**Comment (#113, 114):**

**Figure 145-24—POWER\_ON state, per pairset operating current template for Type 3 PSEs**

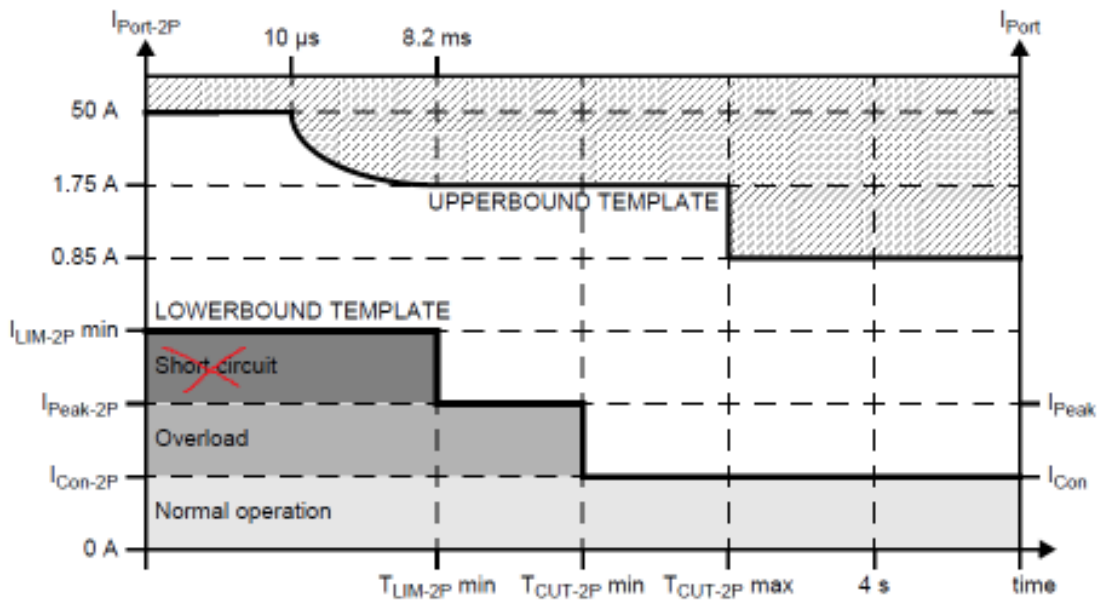
Figures 145-24 and 145-25: Short circuit conditions can't start below the lowerbound template. Specifically, the region between  $I_{peak-2P}$  to  $I_{LIM-2P}$  up to  $T_{LIM-2P}$  is not short circuit.

The  $I_{LIM-2P}$  area is between the lowerbound template and the higherbound template and is the short circuit area as explained by page 154 line 37:

"A PSE may remove power from the PI if the PI current meets or exceeds the "PSE lowerbound template" in Figure 145-24 and Figure 145-25. Power shall be removed from a pairset of a PSE before the pairset current exceeds the "PSE upperbound template" in Figure 145-24 and 145-25."

1. Delete the "Short circuit" label from the region between  $I_{peak-2P}$  and  $I_{LIM-2P\_MIN}$  in Figure 145-24 and Figure 145-25.
2. Change the color of the region between  $I_{peak-2P}$  and  $I_{LIM-2P\_MIN}$  to white.

-Repeat the same corrections in Figure 145-25
